Committee of Experts on the Transport of Dangerous Goods and on the Globally Harmonized System of Classification and Labelling of Chemicals

Sub-Committee of Experts on the Transport of Dangerous Goods

Explosives and related matters: test series 8

Recommendation on the use of 50/50 pentolite donor in the Ammonium Nitrate Emulsions, Suspensions and Gels: Series 8 Test (b)

Figure 1.. Calibration curves for NSW ELSGT, STANAG-4488 and UN TS 7(b) and TS 8(b) gap tests.

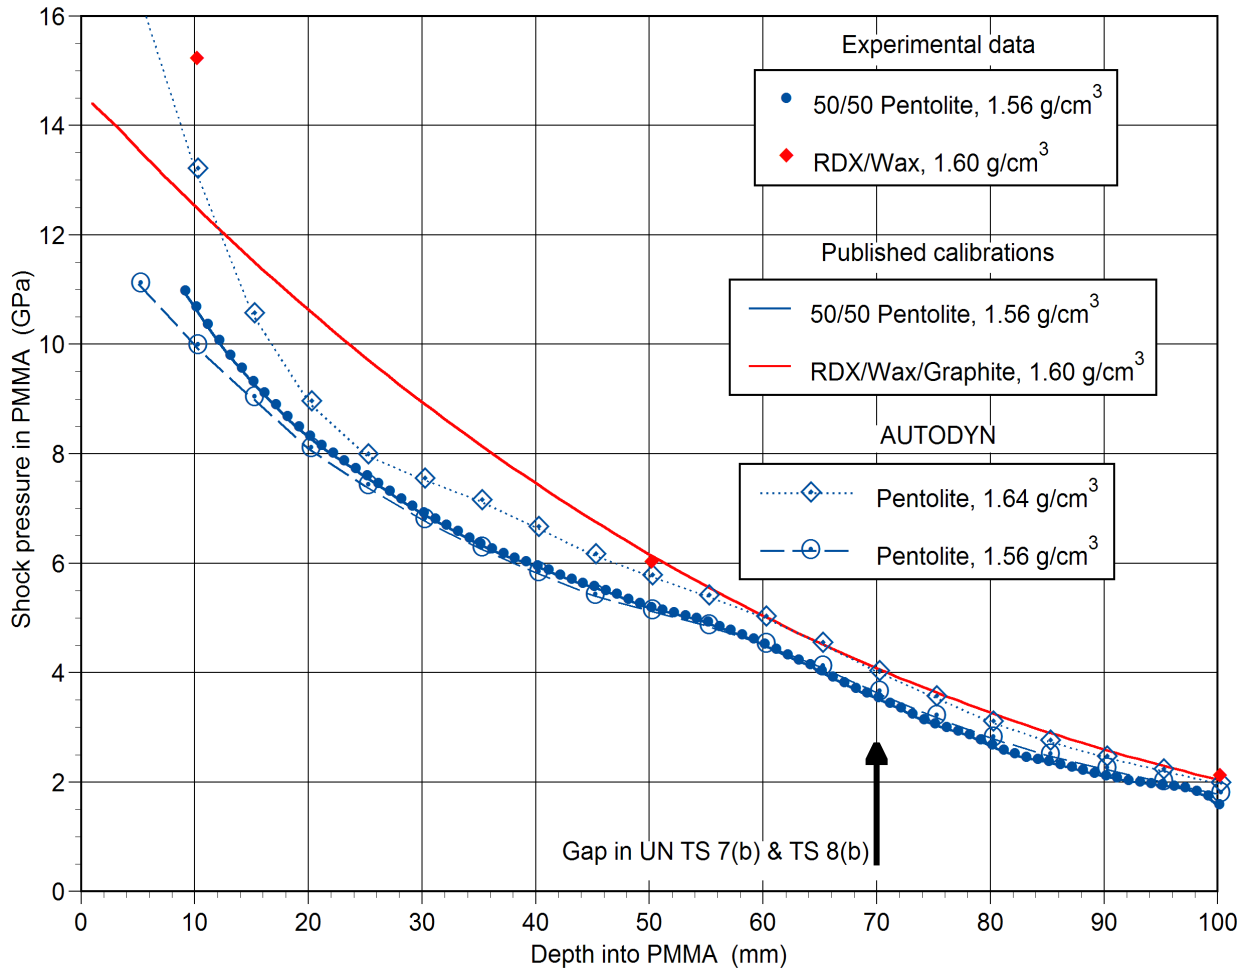
7. It can be seen in Figure 1 that the predicted calibration curve from the simulation assuming 50/50 Pentolite at 1.56 g/cm³ is in excellent agreement with Tasker and Baker's³ experimental data, in particular at the gap length of 70 mm specified in the TS 7(b) and 8(b) gap tests. It can also be seen that the predicted shock pressure at 70 mm gap from the simulation assuming 50/50 Pentolite at its higher cast density of 1.64 g/cm³ is coincidentally very similar to that published for the RDX/Wax/Graphite donor.

8. Two conclusions can be drawn from the information shown in Figure 1.
 - (a) Substituting *cast* 50/50 Pentolite at 1.64 g/cm^3 for *pressed* 50/50 Pentolite at 1.56 g/cm^3 leads to a higher initial shock pressure delivered to the test sample, and hence to a more severe test.
 - (b) Substituting *cast* 50/50 Pentolite at 1.64 g/cm^3 for *pressed* 50/50 Pentolite at 1.56 g/cm^3 leads to an initial shock pressure that falls within the allowable pressure range specified in Table 18.5.1.1 of MTC5 for a gap length of 70 mm.

9. It is recommended that Section 18.5.1.2.1 (b) of MTC5 be modified to read:

“95 mm diameter by 95 mm long 50/50 pentolite or pressed 95/5 RDX/Wax pellet with a density of $1\ 600 \text{ kg/m}^3 \pm 50 \text{ kg/m}^3$,”
10. With this modification in TS8(b), the peak shock pressure at the end of the 70 mm PMMA gap would still fall within the current allowable range if a cast 50/50 Pentolite pellet were used. This modification would allow the pentolite pellets to be cast using the most common manufacturing technique adopted by suppliers of boosters to the mining explosives industry, while still permitting the use of pressed pellets if available from suppliers of military explosives. The modification also brings the TS8(b) donor into better alignment with the TS1(a) and 2(a) gap tests, which actually require their Pentolite donor to be cast.
